Subject: MHI's Responses to US-APWR DCD RAI No.1

Responses to Request for Additional Information No.1 Revision 0

US-APWR Design Certification

RAI NO.: NO.1 REVISION 0
SRP SECTION: 19 – Probabilistic Risk Assessment and Severe Accident Evaluation
APPLICATION SECTION: 19.1
DATE OF RAI ISSUE: 4/17/2008

Figure 1 Gravitational Injection Simplified System Diagram

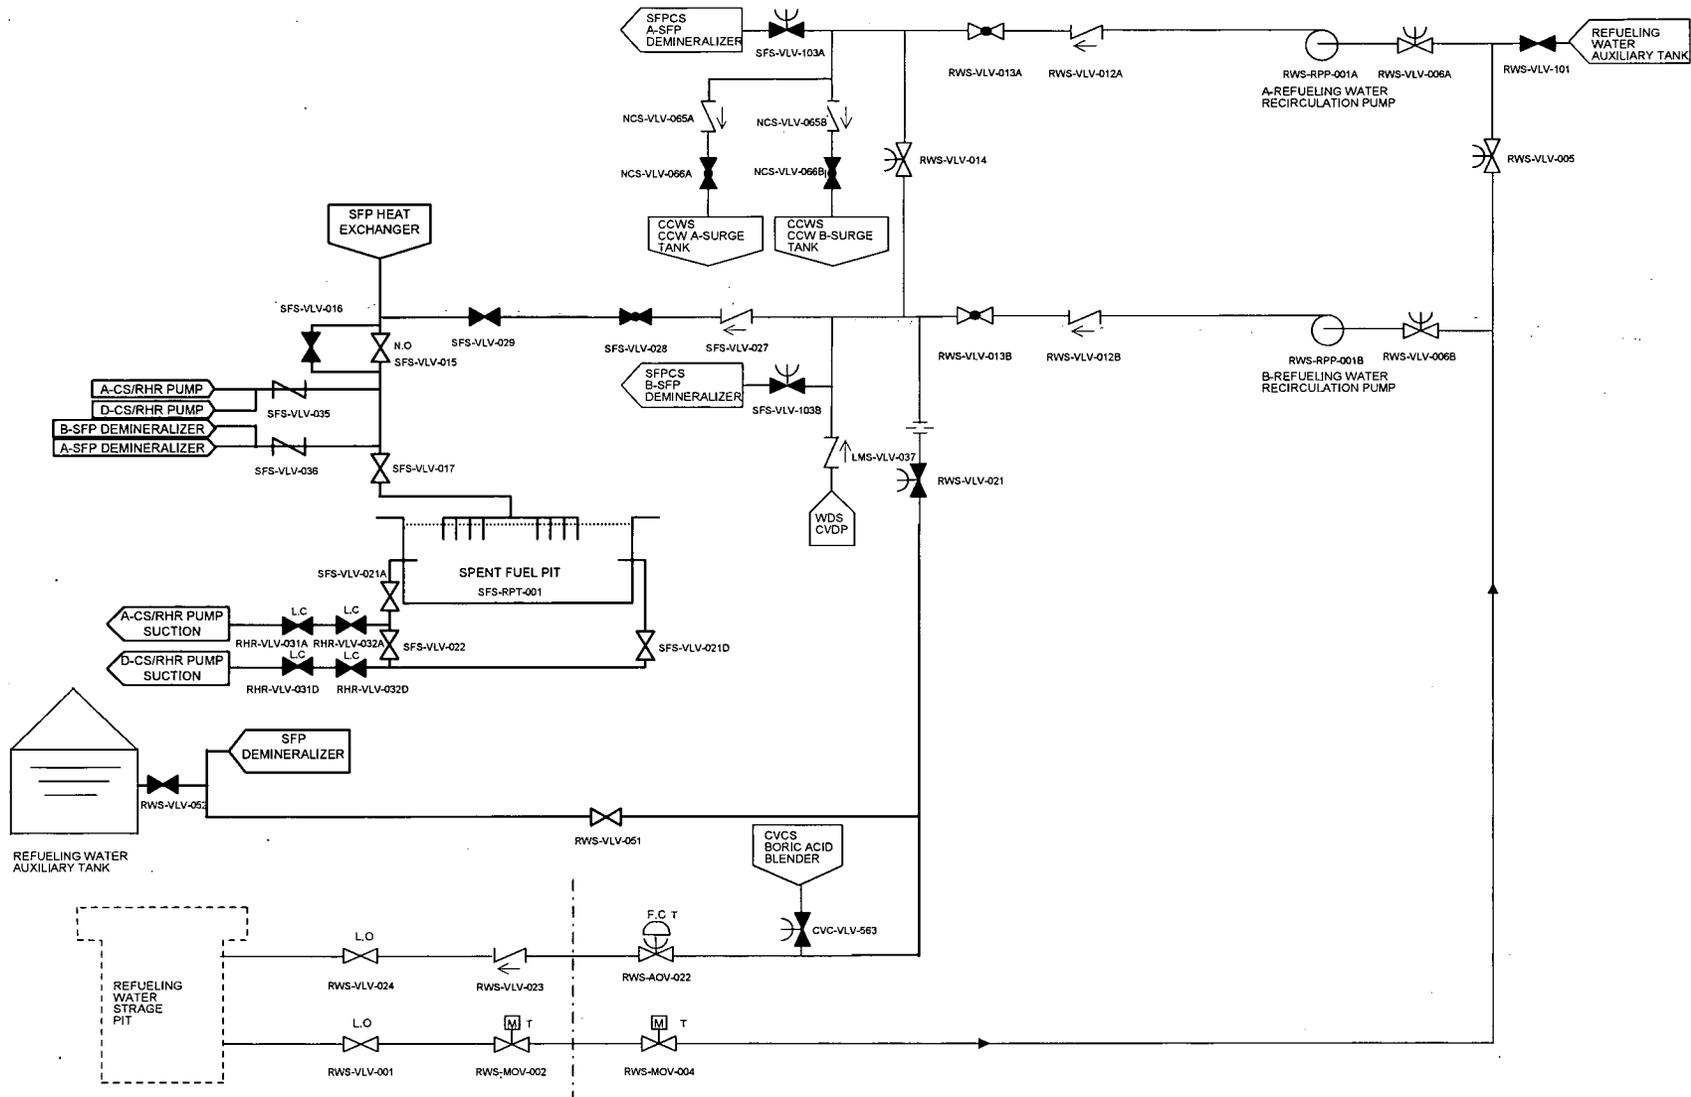
For the GI top event, please discuss the operator actions needed given that the spent fuel pool (SFP) valves are shown as locked closed on system diagrams. Also, identify the minimum vent size needed for success of gravitational injection and discuss how the necessary vent is ensured.

Operator actions are essential to perform gravitational injection. Simplified system diagram of the gravitational injection line is shown in Figure 1.

In order to perform gravitational injection, operator must conduct the following tasks.

1. Establish gravitational injection pass

Open the following valves to initiate gravitational injection from SFP

- RHR-VLV-031A(D)
- RHR-VLV-032A(D)

In the PRA, gravitational injection is taken credit only when large RCS opening such as SG manhole lids are opened. This is a conservative assumption, but it is obvious that gravitational injection is effective when the injection line has been successfully accomplished.

Figure 1 Fault tree of automatic low pressure letdown line isolation

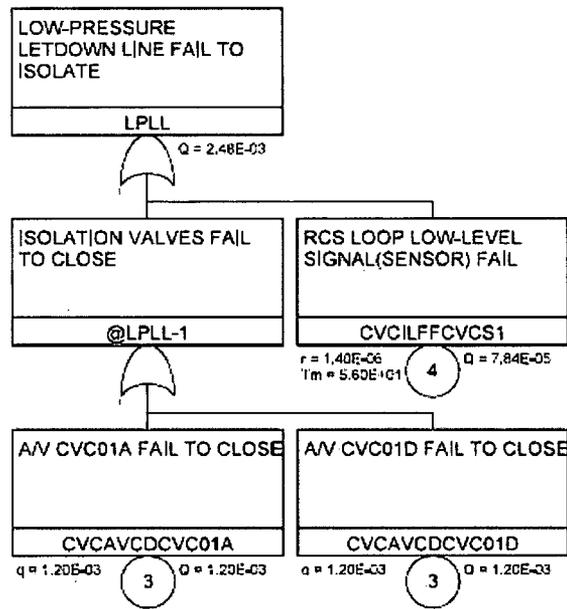
Please clarify the isolation of letdown line (LOB) top event used in the "loss of RHR due to overdrain" (OVDR) event tree. Following an over - drain event, is it expected that the operator must always close the CLVD01 air - operated valve? (Note that this valve is downstream of the letdown isolation valves that are automatically closed on low loop level.) How is the failure probability of the automatically operated letdown isolation valves treated in the OVDR model?

Air-operated letdown isolation valves are design to close automatically upon detection of low loop level. Over-drain initiating event is assumed to occur when the letdown isolation valve fails to close automatically following an over-drain event. Fault tree used to quantify the failure probability of automatically operated letdown isolation valves is shown in Figure 1

Operator action to manually close the air operated valve located downstream the letdown isolation valves is taken credit as a mitigation function following over-drain initiating event.
